UNITED STATES PATENT AND TRADEMARK OFFICE

APPLICATION NO.	FILING DATE	FIRST NAMED INVENTOR	ATTORNEY DOCKET NO.	CONFIRMATION NO.
10/688,877	10/21/2003	Mizuki Murata	2257-0236P	9350
2292	7590	05/04/2005	EXAMINER	
BIRCH STEWART KOLASCH & BIRCH PO BOX 747 FALLS CHURCH, VA 22040-0747			QUARTERMAN, KEVIN J	
			ART UNIT	PAPER NUMBER
			2879

Office Action Summary

DETAILED ACTION

Figure 1

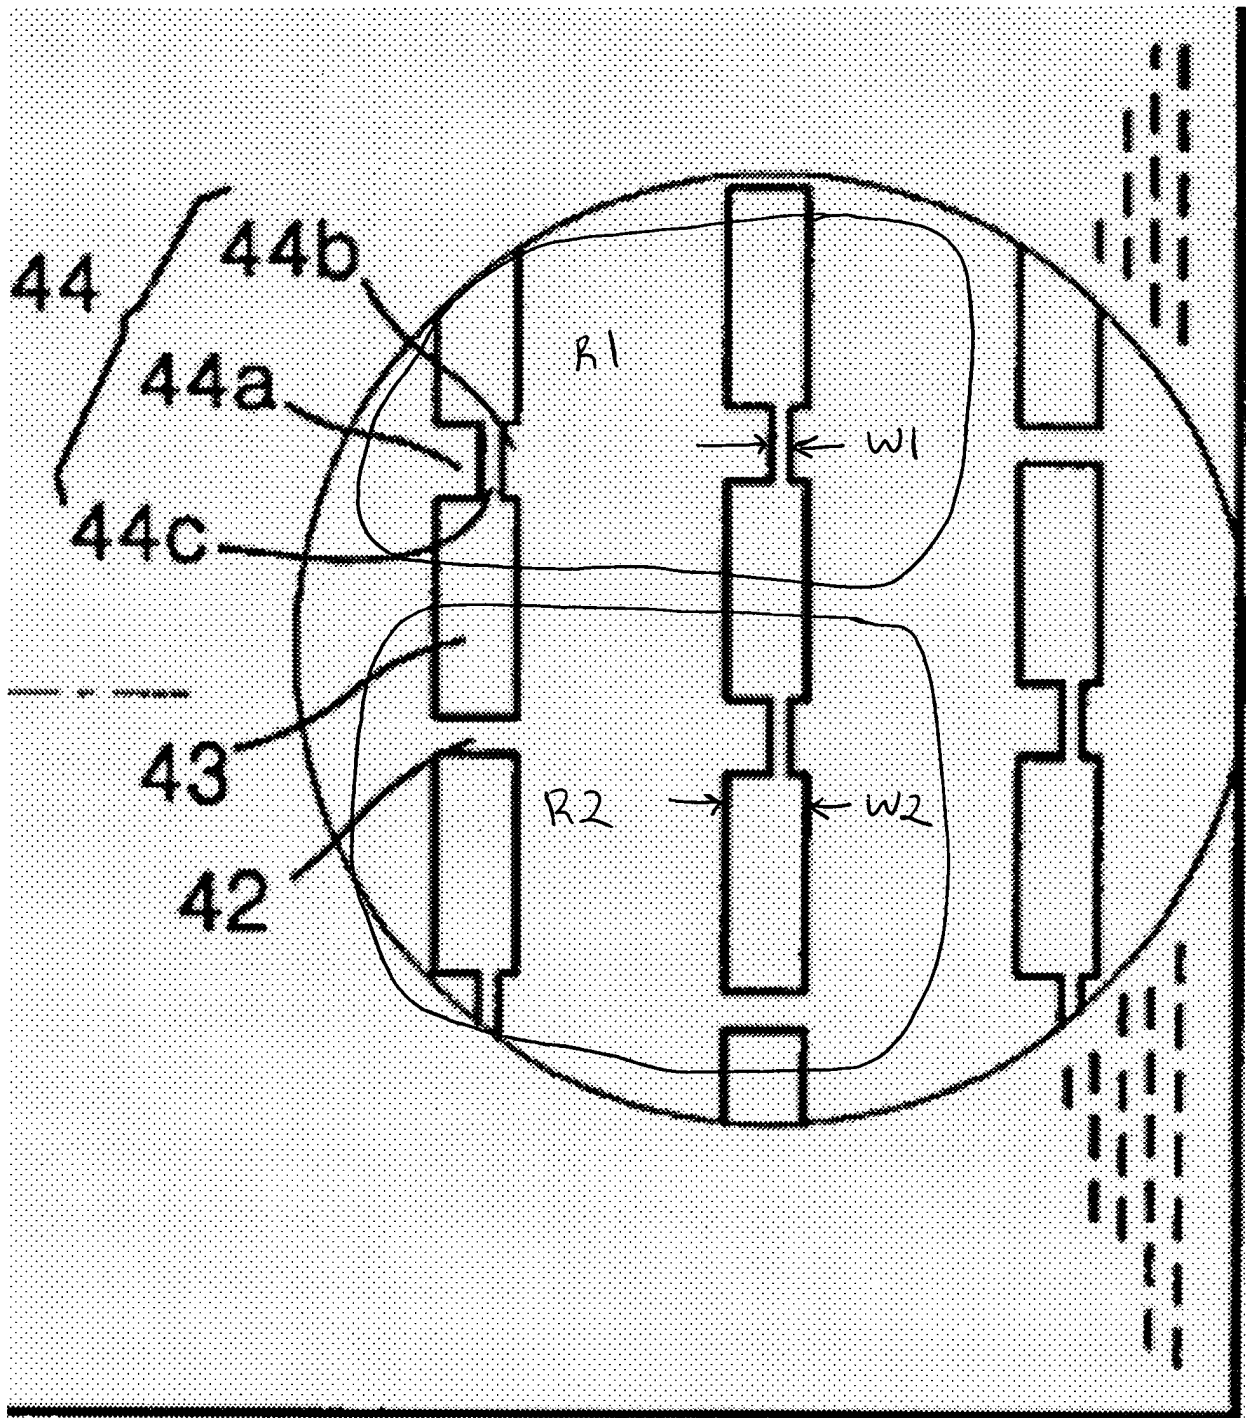
4. Claims 1 and 3 are rejected under 35 U.S.C. 102(e) as being anticipated by Shin (US 6,614,154).
5. Regarding independent claim 1, Figures 6 and 7 of Shin '154 show a shadow mask for a color cathode ray tube comprising a plurality of strips (41); real bridges (42) for connecting the strips adjacent to each other; and dummy bridges (44a, 44b) formed in cantilevered fashion on a side part of the strips, wherein a region in which only the dummy bridges are present among the dummy bridges and the real bridges is defined as a first region, and a mixed region having the dummy bridges and the real bridges is

defined as a second region, and wherein the size of the dummy bridges (44a) in the first region is greater than the size of the dummy bridges (44b) in the second region.

7. Thus, Figure 1 illustrates a reproduced portion of Fig. 7 of Shin '154 showing a first region R1 in which only the dummy bridges are present and a second mixed region R2 having both the dummy bridges and the real bridges.

8. Regarding independent claim 3, Figures 6 and 7 of Shin '154 shows a shadow mask for a color cathode ray tube comprising a plurality of strips (41) and real bridges (42) connecting the strips adjacent to each other, wherein a striped mask region devoid of the real bridges is defined as a first region, and a region having the real bridges is defined as a second region, and wherein a slit opening width in the first region is less than a slit opening width in the second region. Also, see Examiner's discussion (§ 6) for the term "region" cited earlier in this office action.

9. Figure 1 also shows the first region R1 devoid of real bridges and the second region R2 having the real bridges. The figure also shows a slit opening width W1 in the first region being less than a slit opening width W2 in the second region.

Figure 2

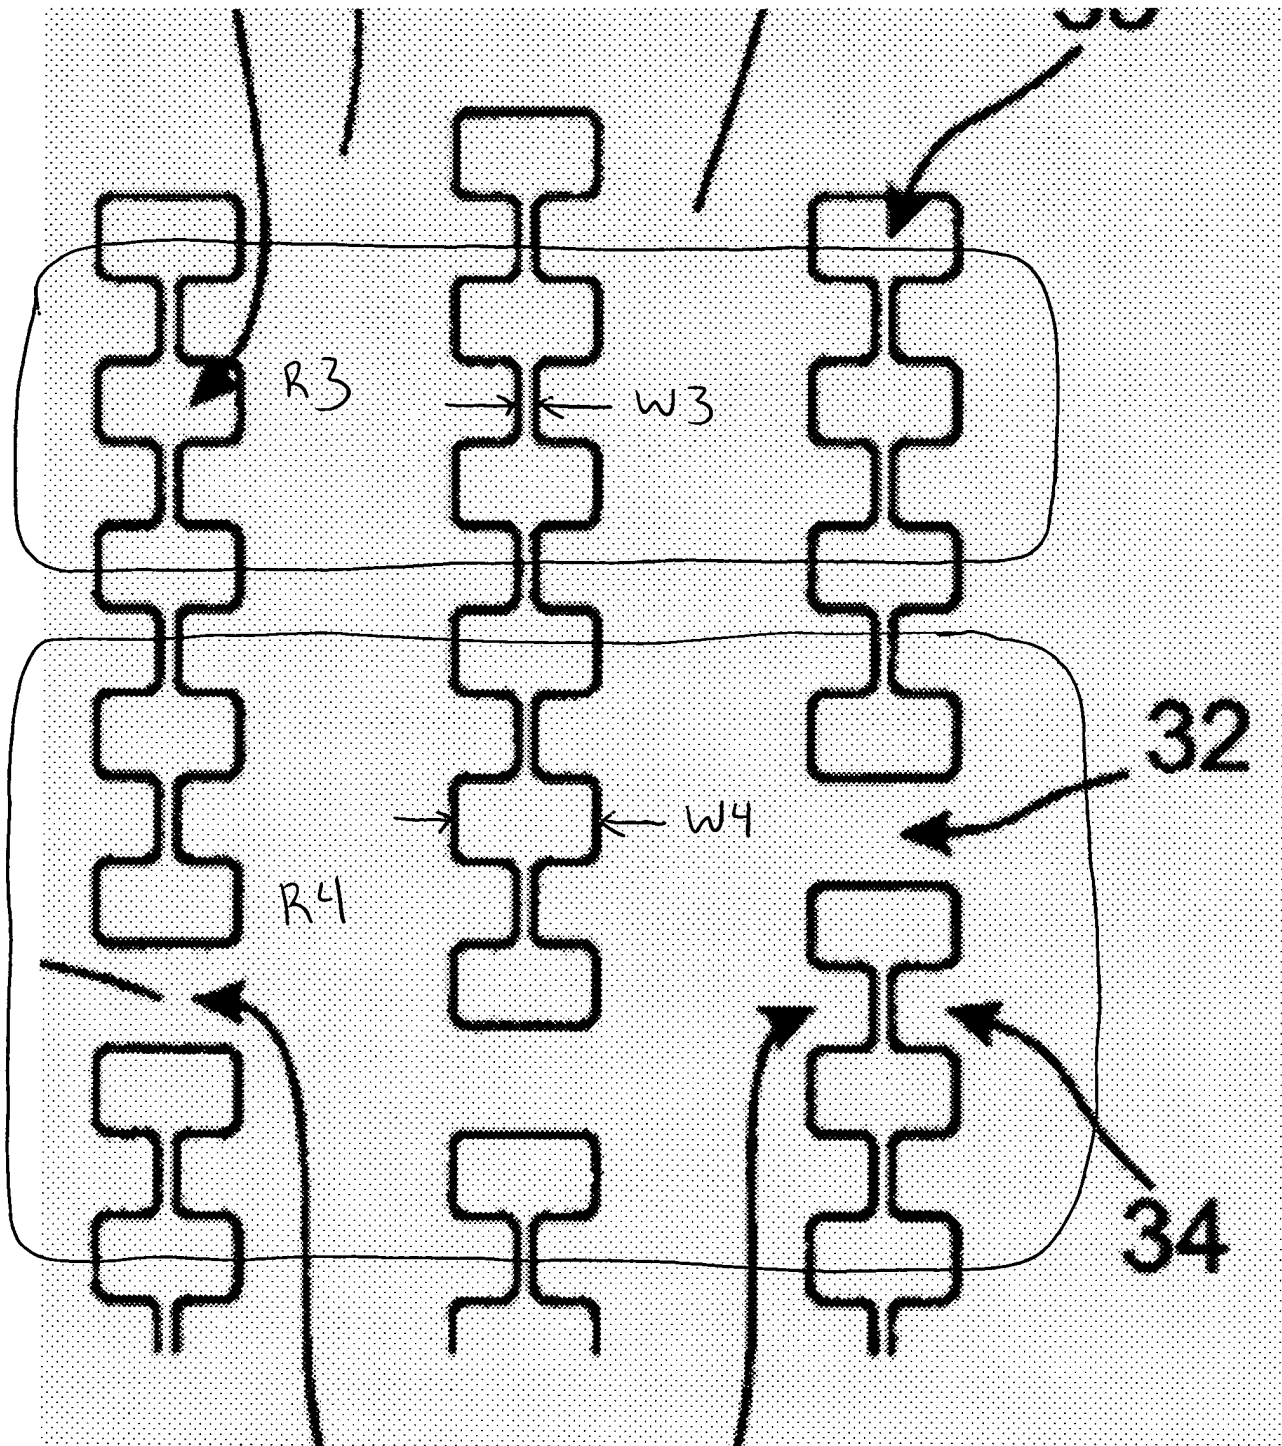
11. Regarding independent claim 3, Figure 4 of Shin '775 shows a shadow mask for a color cathode ray tube comprising a plurality of strips (31) and real bridges (32) connecting the strips adjacent to each other, wherein a striped mask region devoid of the real bridges is defined as a first region, and a region having the real bridges is defined as a second region, and wherein a slit opening width in the first region is less than a slit opening width in the second region.

12. Figure 2 illustrates a portion of Fig. 4 of Shin '775 showing the first region R3 devoid of real bridges and the second region R4 having the real bridges. The figure also shows a slit opening width W3 in the first region being less than a slit opening width W4 in the second region.

17. Figure 2 illustrates a reproduced portion of Fig. 4 of Shin '775 showing a first region R1 in which only the dummy bridges are present and a second mixed region R2 having both the dummy bridges and the real bridges.

18. Shin '775 teaches the claimed limitations of independent claim 5, as discussed earlier, but fails to exemplify the size of the dummy bridges in the first region being greater than the size of the dummy bridges in the second region.
